Access Compliance Report Public Rights-of-Way (Curb Ramps)

Intersection ID: 7373Main Street: TOM_HUNTER_RDCross Street: WHITE_PLAINS_RDLocation:SEADA ID: 1617E2A4205DRamp Type: ParaInitial Pass/Fail: FailOverall Compliance: NoSeverity Score: 1.25

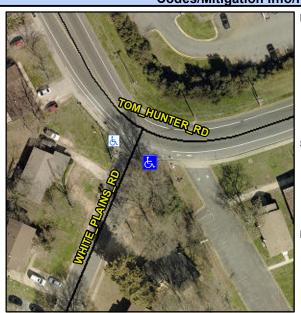
RT RP < 5%

R304.5.3

Remove & Replace Entire Ramp.
